**QUALITY ASSURANCE -- NON-CONFORMANCE REPORT**

**Location:** Changxing Island, Shanghai, P.R. China **Report No:** NCR-000520  
**Prime Contractor:** American Bridge/Fluor Enterprises, a JV **Date:** 25-Nov-2009  
**Submitting Contractor:** Zhenhua Port Machinery Company, Ltd (ZPMC), Changxing Island **NCR #:** ZPMC-0493

**Reference Description:** Transverse Linear indication discovered with MT after the contractor's NDT acceptance for Segment 12CW

**Job Name:** SAS Superstructure

### 焊缝返修位置示意图:

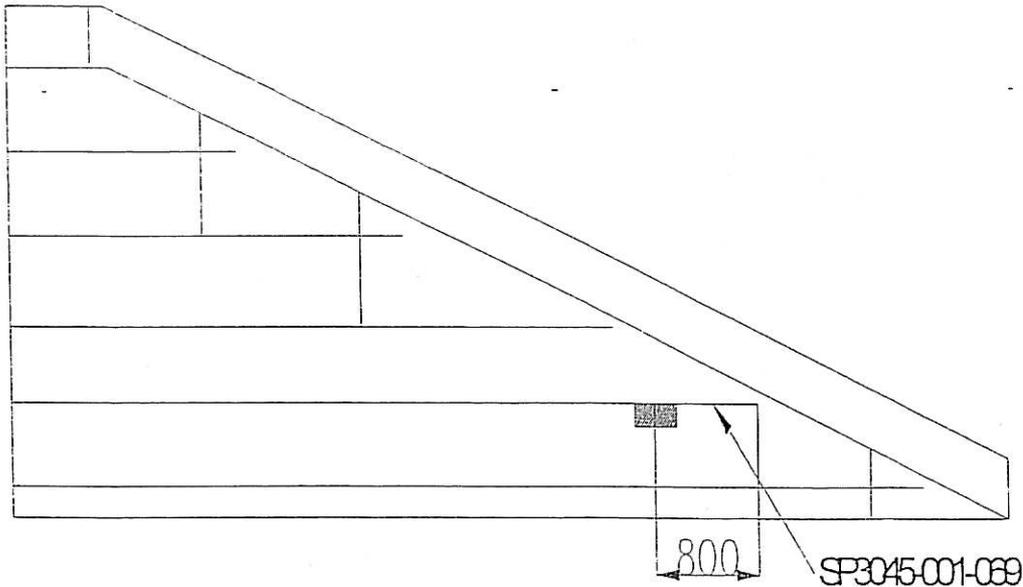
SP3045-001-069在完工打磨焊缝时, 打磨工不慎将母材磨伤达2mm之深。

The base metal was gouged after grinding, 2mm in depth, weld ID: SP3045-001-069.

Worker operated error caused base metal gouged.

1. Remove all the defects according to the approved repair WPS by means of grinding.
2. Verify with MT and VT no defects remain in the repair area prior to-weld;
3. Preheat and weld according to the relevant WPS.
4. Grind the weld flush with base metal after welding.
5. Perform VT and MT inspection of the repaired area.
